Access Compliance Report

Public Rights-of-Way

(Curb Ramps)

Intersection ID: 11148	Main Street: MATHESON_AV	Cross Street: VIRGINIA_AV	Location: W
ADA ID: 982D1335D017	Ramp Type: PerpDiag	Initial Pass/Fail: Fail	Overall Compliance: No
			Severity Score: 21.25

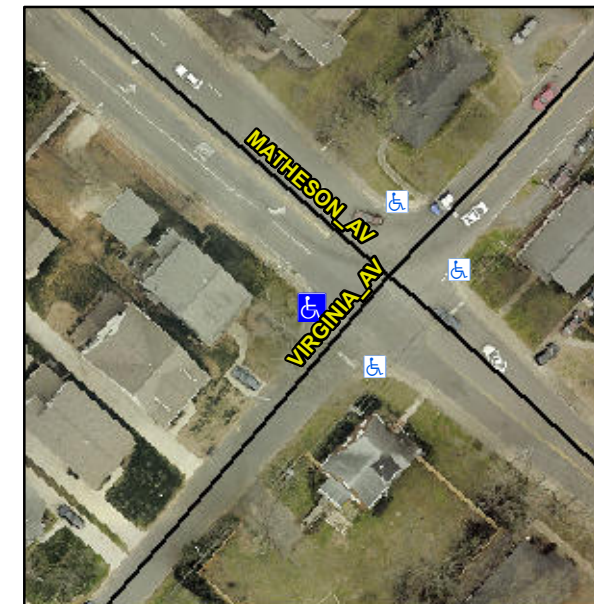
Compliance	Description	Data	Compliance	Description	Data
N/A	Ramp Length (in)	48.5	No	Ramp Slope (%)	8.6
No	Ramp Width (in)	43.0	Yes	Ramp XSlope (%)	0.6
N/A	Flare Type LT	N/A	N/A	Flare Type RT	N/A
N/A	Flare Slope LT (%)	N/A	N/A	Flare Slope RT (%)	N/A
N/A	Flare Traversable LT?	N/A	N/A	Flare Traversable RT?	N/A
N/A	Landing Length (in)	N/A	N/A	DWS Provided?	N/A
N/A	Landing Width (in)	N/A	N/A	DWS Contrast?	N/A
N/A	Landing Slope (%)	N/A	N/A	DWS Length (in)	N/A
N/A	Landing X Slope (%)	N/A	N/A	DWS Full Width?	N/A
N/A	Landing Curb? (Y/N)	N/A	N/A	DWS Offset (in)	N/A
N/A	Shared Landing?	N/A			
N/A	Gutter Ponding?	N/A	N/A	Gutter Slope (%)	N/A
N/A	Gutter Lip Ht (in)	0.5	N/A	Gutter X Slope (%)	N/A
N/A	Painted X Walk1?	No	N/A	Painted X Walk2?	No
	X Walk 1 Direction	To SE		X Walk 2 Direction	To NE
N/A	X Walk 1 Width (in)	N/A	N/A	X Walk 2 Width (in)	N/A
	X Walk 1 Slope (%)	2.0		X Walk 2 Slope (%)	0.7
	X Walk 1 X Slope (%)	0.9		X Walk 2 X Slope (%)	2.3

Remove & Replace Curb Ramp With Two New Directional Ramps or Equivalent.
